DISABLED ACCESS COMPLIANCE DOCUMENTATION FORM

TENANT IMPROVEMENT PLAN CHECK COMMENTS

PLAN CHECK NO:	10173635,6,7		
PROJECT ADDRESS:	1831 S Ritchey St, 1917 E St. Andrews AND 1918 E Glenwood Pl.		
PLAN CHECK ENGINEER:	Kwak, Jason	TEL: 714	647-5866
		FAX: 714	647-5897
TYPE OF CONSTRUCTION:	V B		
OCCUPANCY CLASSIFICATION(S):	B, S-1		
PLAN CHECK DATES:		REMARKS/RECHECK ITEMS:	
APPLICATION	11/7/2011	_____	
INITIAL REVIEW	11/23/2011	_____	
EXPIRATION	5/5/2012	_____	
RECHECKS:	1. _____	PROJECT APPLICANT CONTACT PERSON:	
	2. _____	Michael Santillan	
	3. _____	TEL:	(949)716-9990
VALUATION:	\$30,000.00	FAX:	_____
FLOOD ZONE:	X-0602320277J	EMAIL:	michael.santillan@nationaleng.com

RE: 1917 E. St. Andrew Place
Plan Check # 10173636

SCALE N.T.S. 3 WALL ANCHORAGE SCALE 3/4"=1'-0" 4

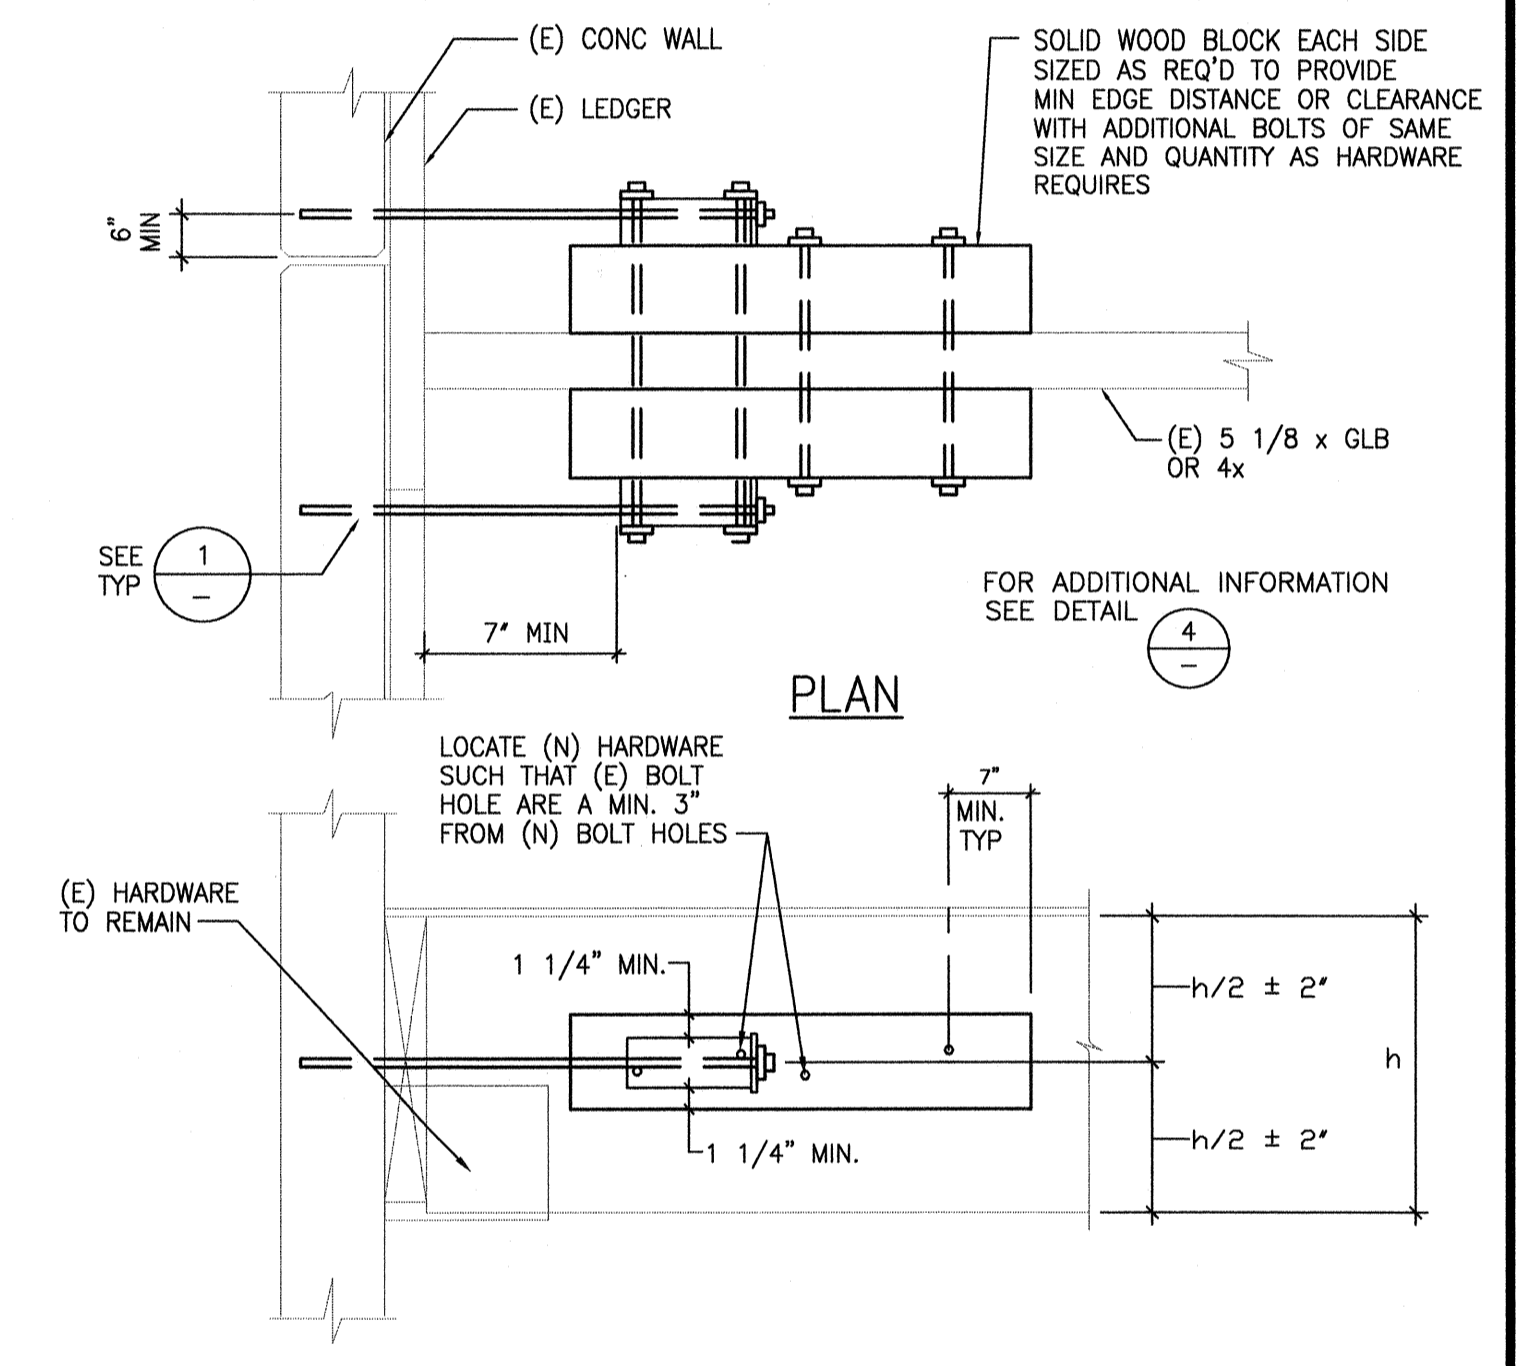
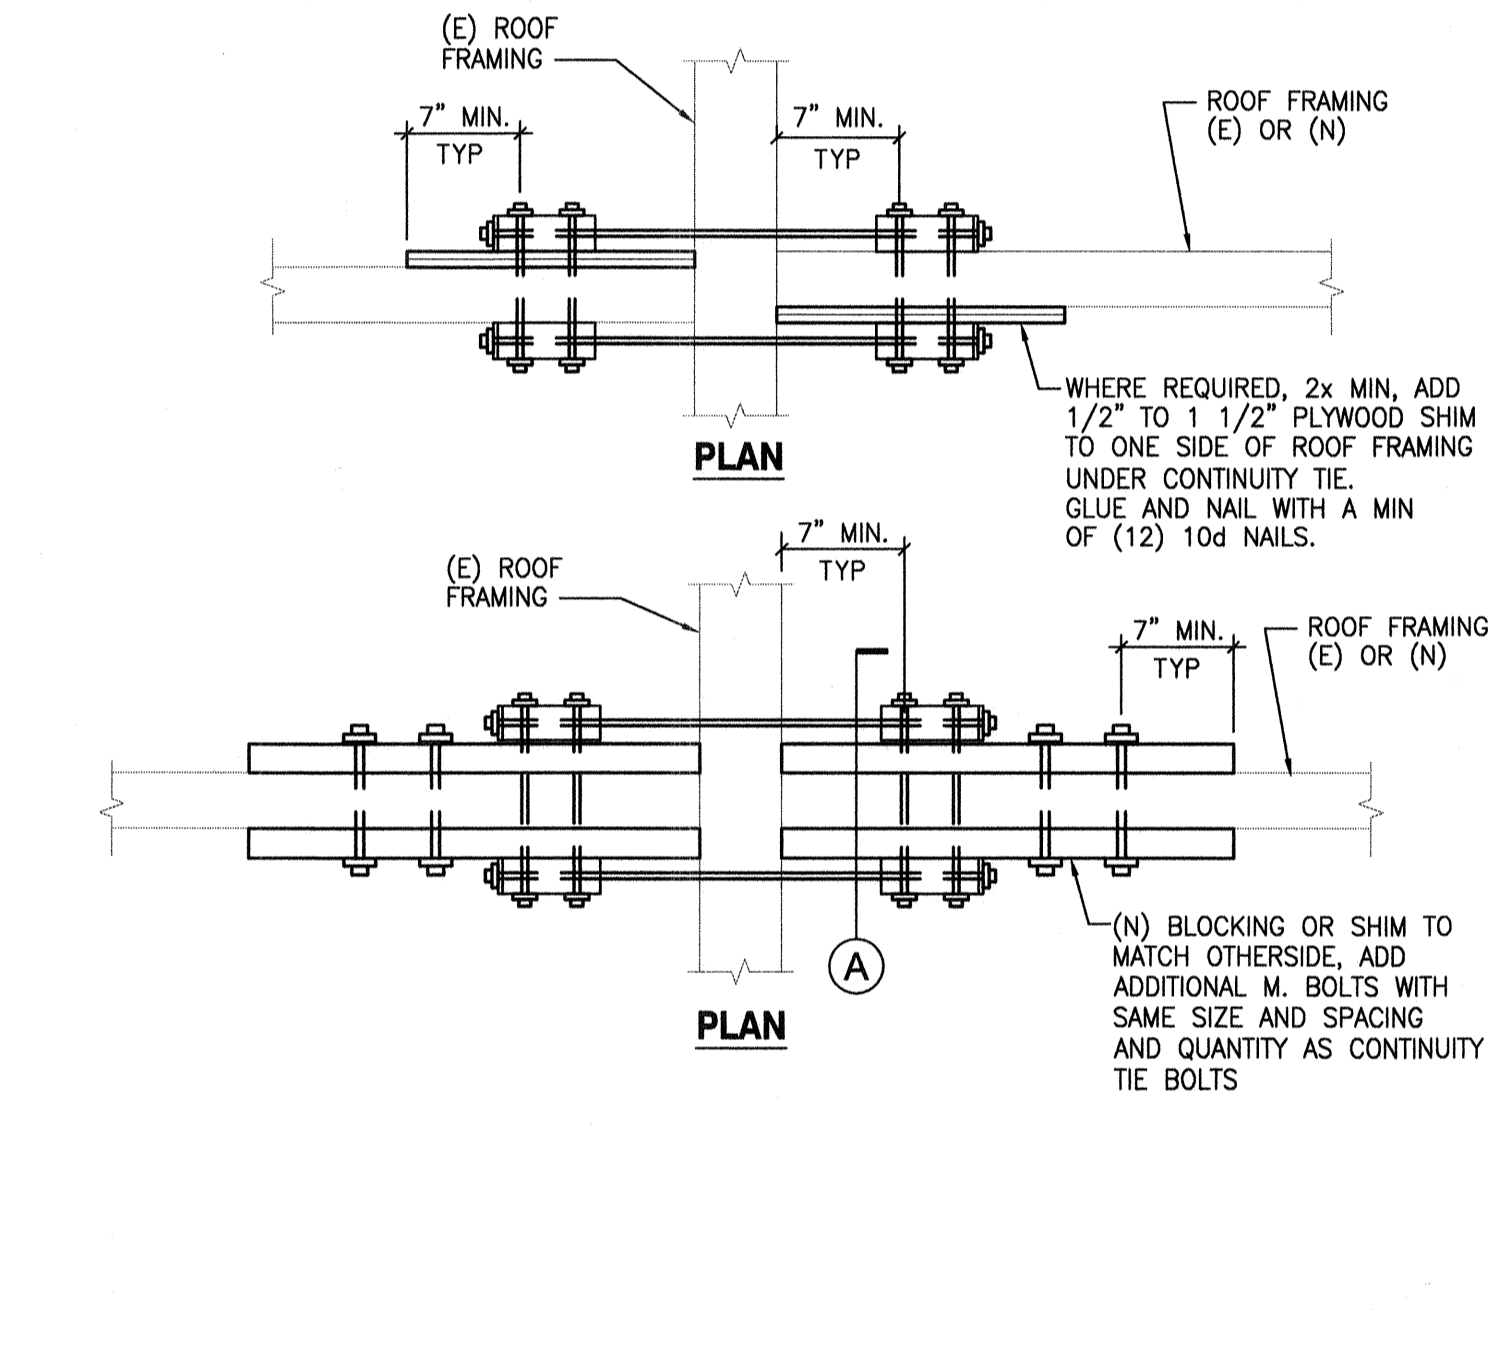
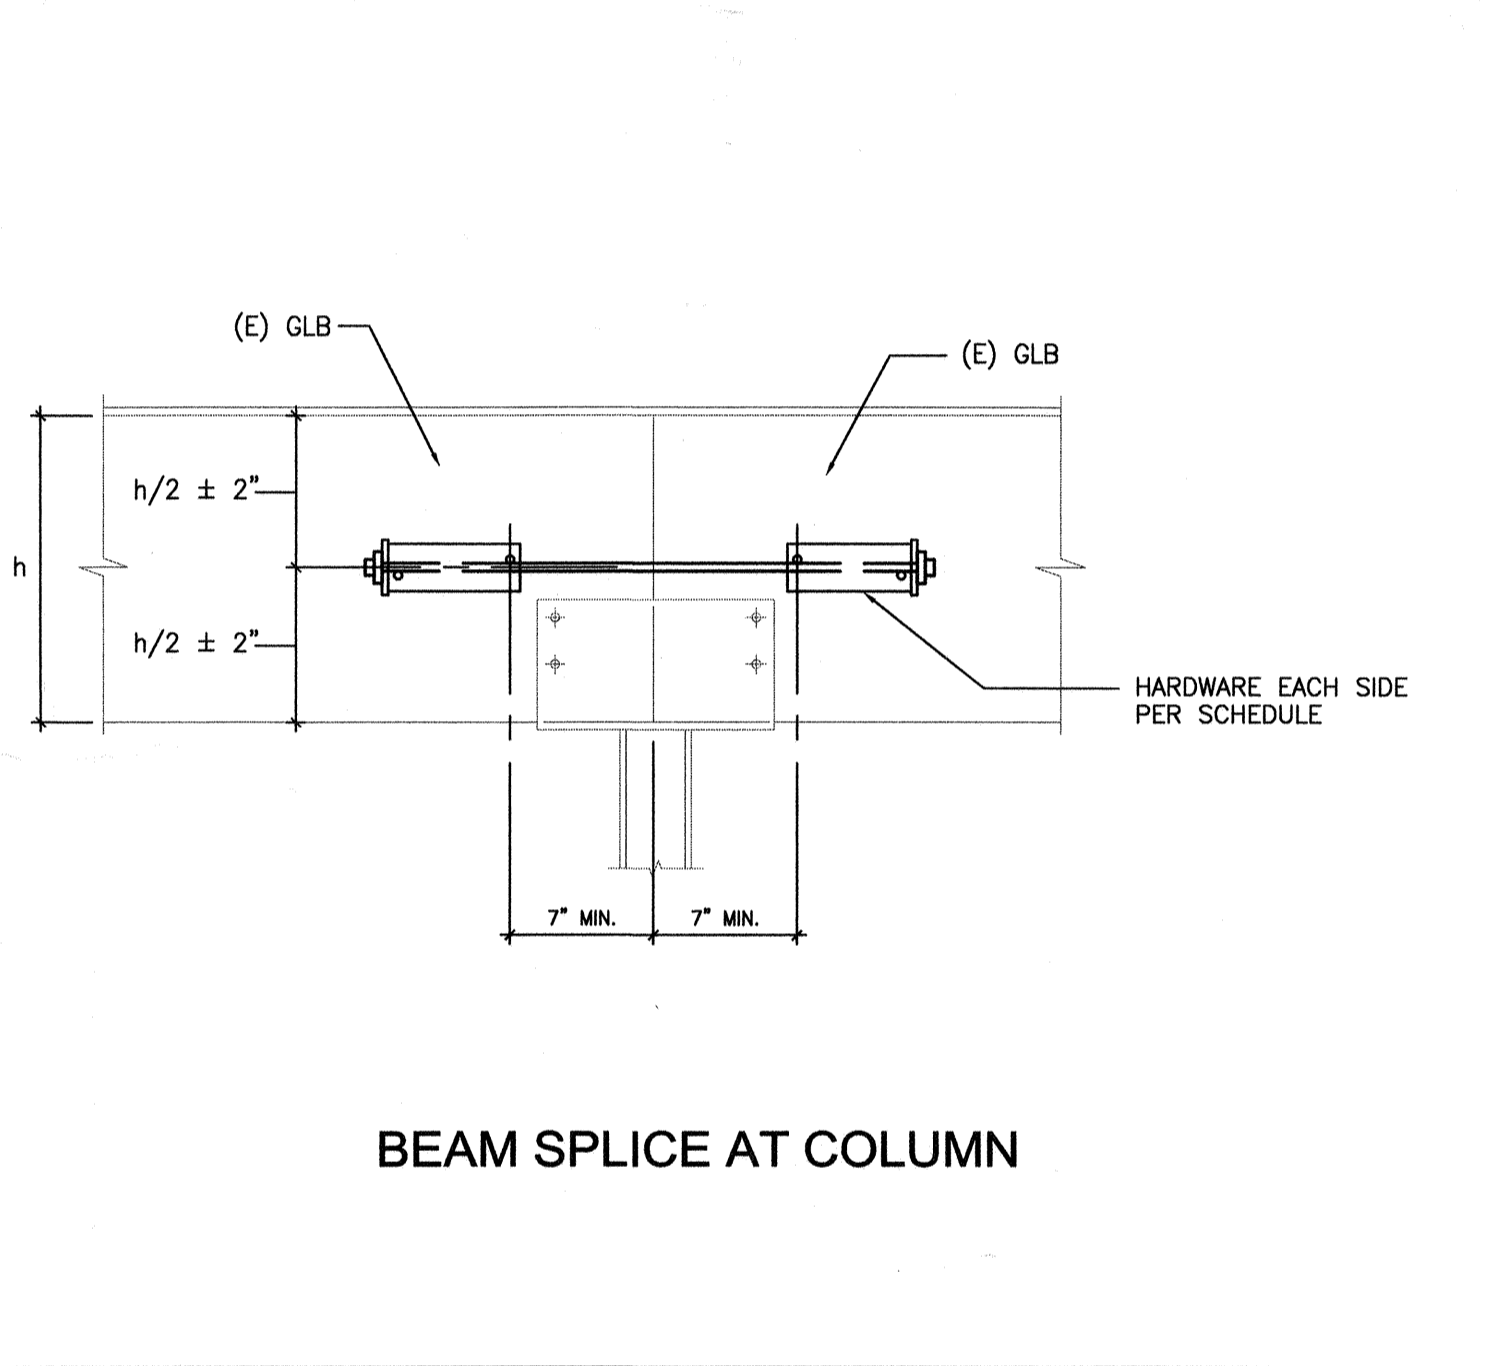
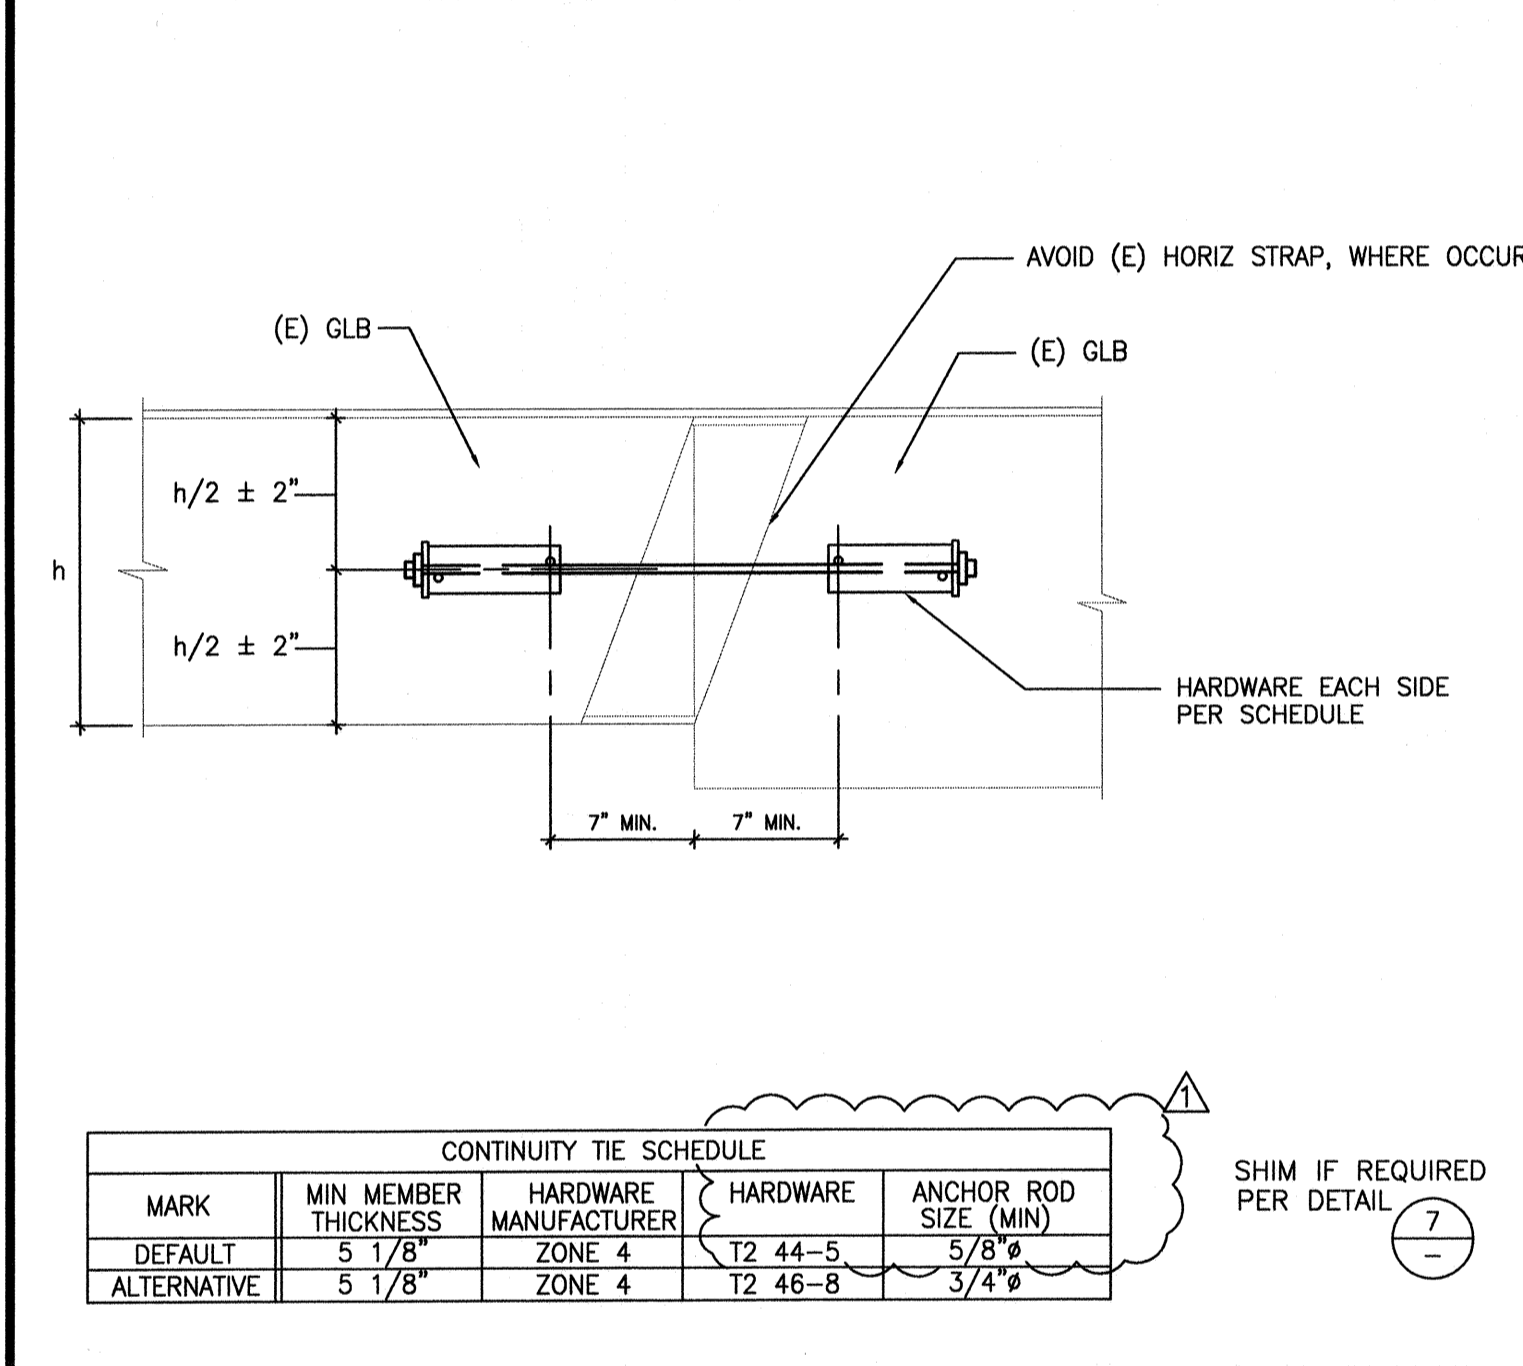
13. Provide completed disabled accessible compliance form (attached) with each project.
14. Provide ICC or LA RR listing number on plans for Zone 4 hardware.

Provide ICC or LARR listing number on plans for Zone 4 hardware

Response: Complied. The LARR is 25334 and approved as of November 1, 2011. See structural plans detail 4/SD-1. As part of this approval, Zone4 revamped their product line and developed new capacities which I have attached.

- The old continuity tie T2-44-6 is now a T2-44-5 with greater capacity (Details 2 & 6/SD1).
- The old wall anchor T2-24-6 is now a T2-24-4 with greater capacity (Detail 4/SD1).
